January 4, 2008

Re: Hartwood Marsh Road – Phase I; Application Number 40-069-114354-1
(Please reference the above name and number on all correspondences)

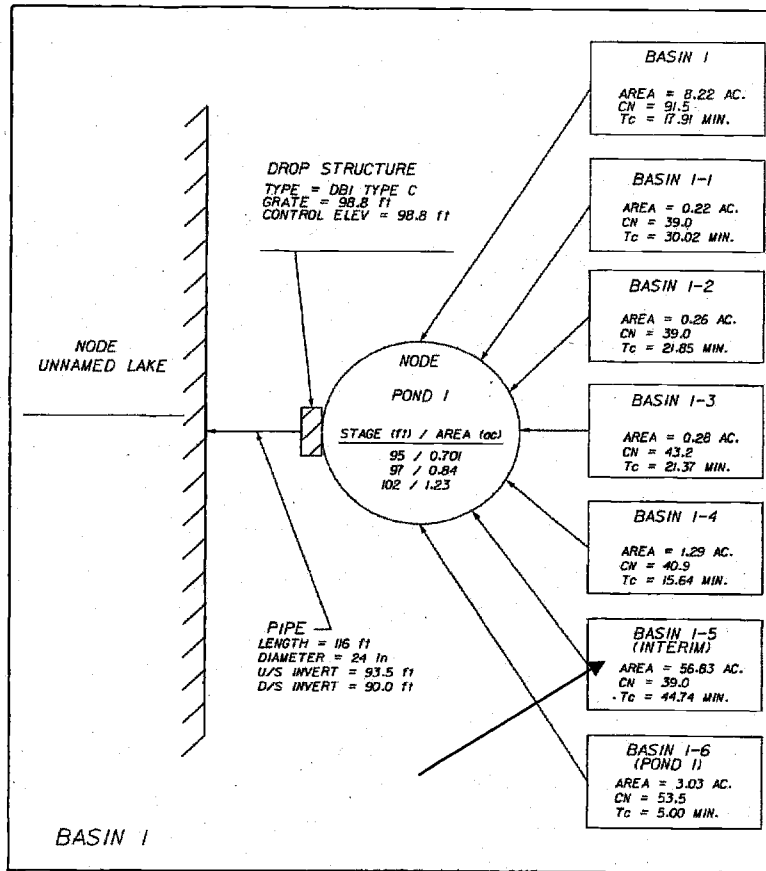
3. Section 7.1 of the Drainage Calculations submitted states, in part, “*In the post development condition, the basin area contributing to Pond 1 consists of the roadway (Sta. 103+43 to Sta. 138+50) and offsite basins directly adjacent to the road. Pond 1 is considered a separate basin. The runoff from the area surrounding the pond will be bypassed around the pond. Pond 1 will discharge to the unnamed lake.*”

Please note that this appears to be inconsistent with the post development *Pond 1 Nodal Diagram* submitted, which indicates that runoff from *BASIN 1-5 (INTERIM)* will be routed into *Pond 1*, in addition to the offsite basins directly adjacent to the road. Reference the following excerpts from the Drainage Calculations submittal.

- a. Accordingly, please revise the set of construction plans to clearly show the boundary limits of all areas draining to the proposed *Pond 1* system.
 - Ensure that these areas have been accounted for in the water quality and quantity calculations.
 - Be advised that stormwater treatment systems must be designed to provide the required treatment and attenuation from the entire contributing basin area (including the pond).
- b. For the proposed diversion of any off-site basin runoff flow around *Pond 1*, revise the set of plans to include a more detailed grading plan for the construction activity in its entirety.
 - Show how the proposed contour lines will tie into the existing contours along the outer perimeter of the proposed diversion area.
 - Include cross-section details, as needed, to clarify the proposed grades.
 - Show the extent of any fill to be placed, if applicable.

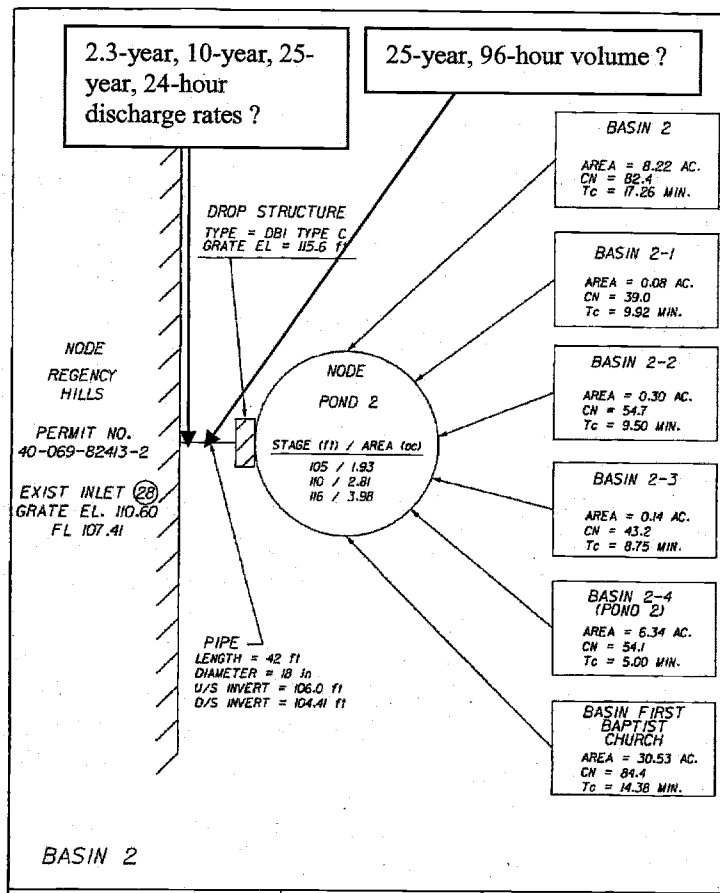
10. Based on the incomplete water quantity analyses provided, it cannot be determined as to whether or not the proposed discharge from *Pond 2* will meet or exceed the discharge rates and volumes previously established by District Permit No. 40-069-82413-2 for the Regency Hills system. Reference the following notations provided on the excerpt below.

Accordingly, please clarify. Provide additional calculations demonstrating that the post-development discharge rates and volumes from *Pond 2* will not exceed those previously established for the Regency Hills system. Include all supporting information. [40C-4.301(1)(a)(b)(c)(i), F.A.C.]

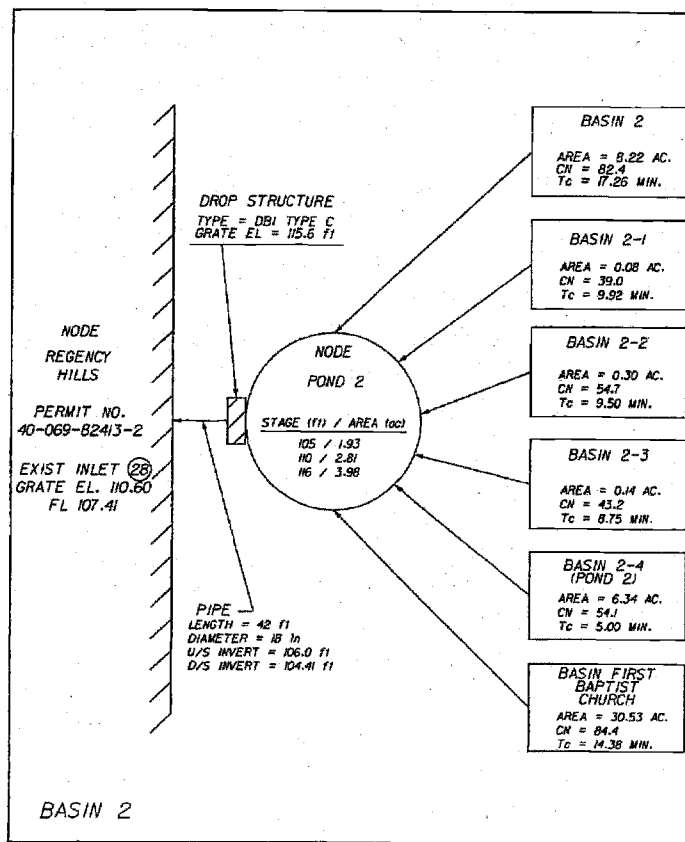
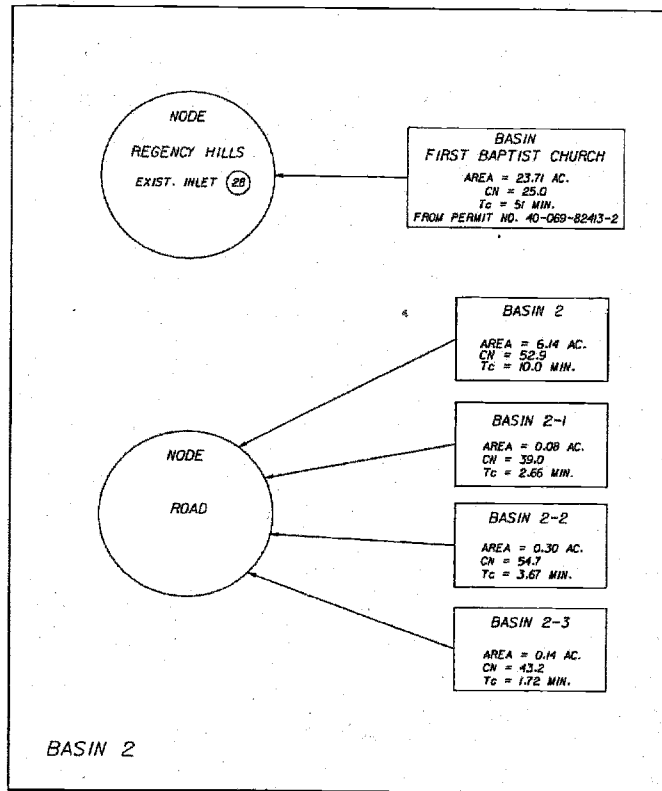
- 13. Please provide documentation from the appropriate entity allowing the connection of the *Pond 2* overflow into the existing Regency Hills surface water management system. Be advised that the previously permitted master system did not include the overflow discharge from the additional basin areas. Reference the following excerpts.

Be advised that this documentation is needed in order to verify District presumptive criteria pursuant to 40C-42.025 (6) ***Design and Performance Criteria for Stormwater Management Systems***, which states that *the applicant must obtain sufficient legal authorization as appropriate prior to permit issuance for stormwater management systems which propose to utilize offsite areas to satisfy the requirements in subsection 40C-42.023(1), F.A.C. [40C-4.301(1)(i); 40C-42.025(6); 40C-42.026(1), F.A.C.]*
